STAFF REPORT PLANNING MANAGER DECISION

FILE NO.: DR-20-01

REQUEST: Approval of a Class I Historic Design Review at 1798 4th Avenue

EXISTING WINDOW

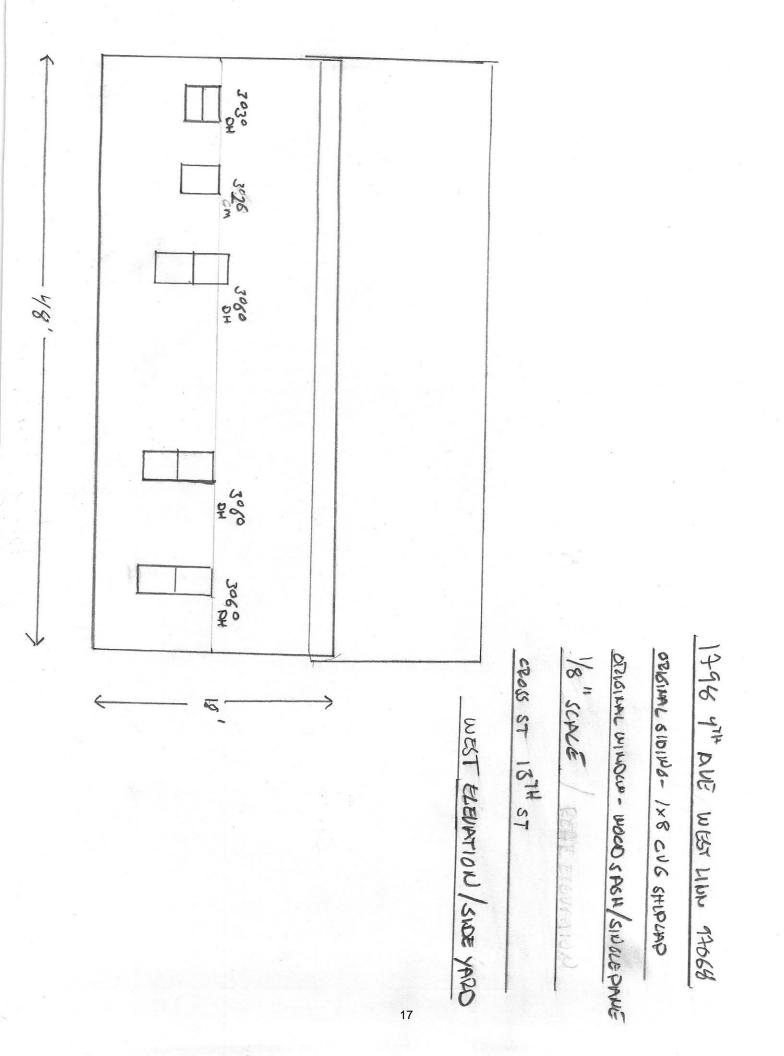
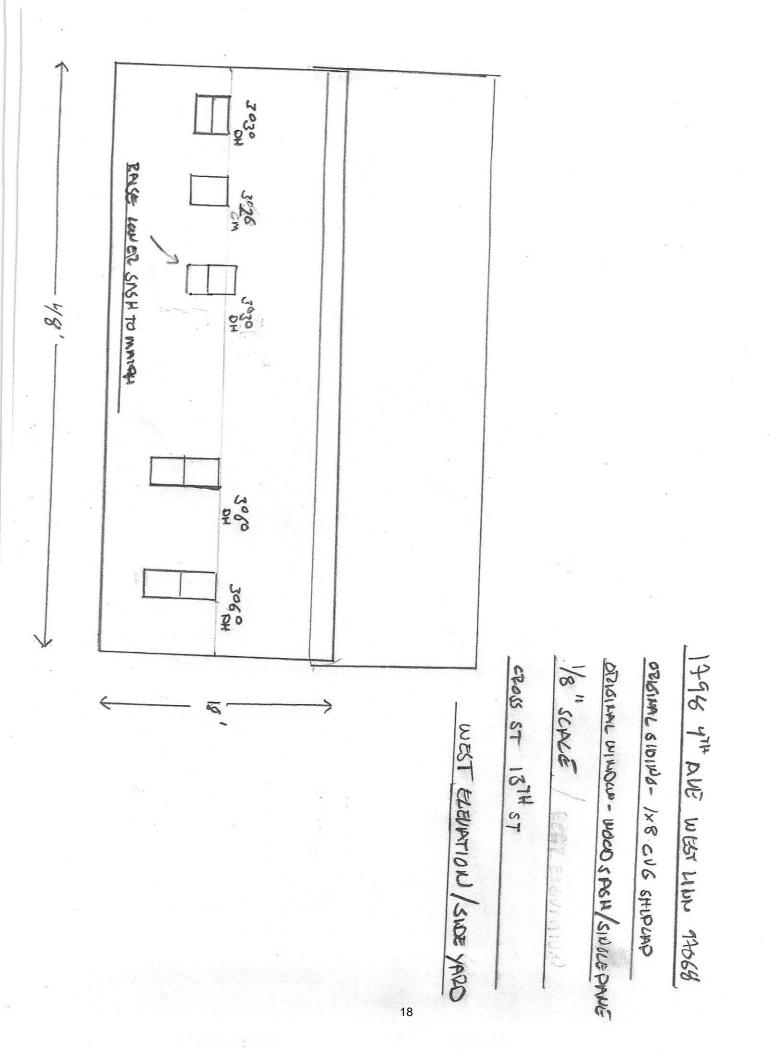
Staff Finding 6: The applicant proposes to replace the existing 70-inch double-hung wood window with a new 44-inch double-hung wood window. The profile and proportion of the sash, light patterns, and glass will remain the same (Pages 10-11, Exhibit PD-1). The existing sill and trim will be reconfigured to fit the smaller window. The criteria are met.

Staff Finding 8: The applicant proposes to replace the existing 70-inch double-hung wood window with a new 44-inch double-hung wood window. The profile and proportion of the sash, light patterns, and glass will remain the same (Pages 10-11, Exhibit PD-1). The existing sill and trim will be reconfigured to fit the smaller window. The criteria are met.

PROPOSED WINDOW

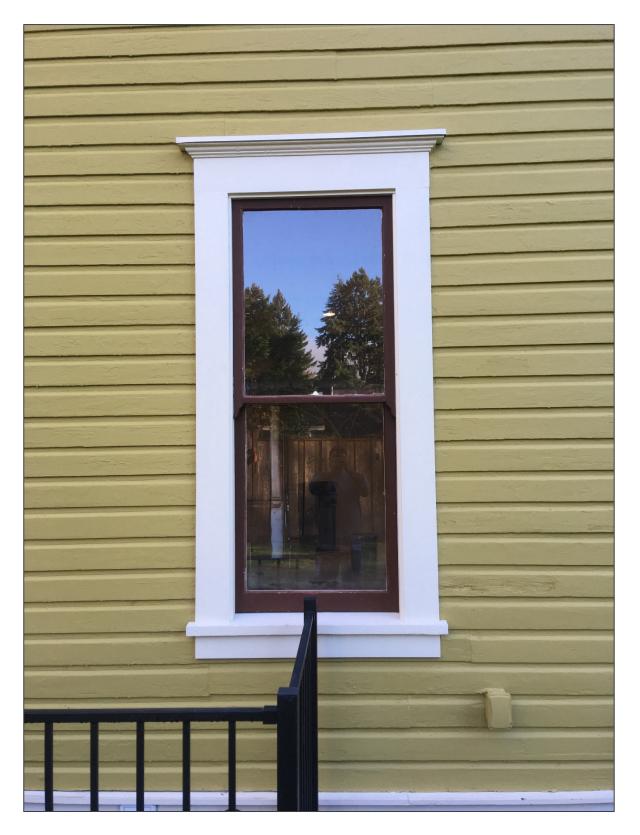
Staff Finding 4: The proposal will reduce the height of an existing window from 70 inches to 44 inches. Existing wood trim and sill will be reconfigured to fit new window size, and new mixed-grain fir siding will be manufactured to match the existing wood siding. The criteria are met.
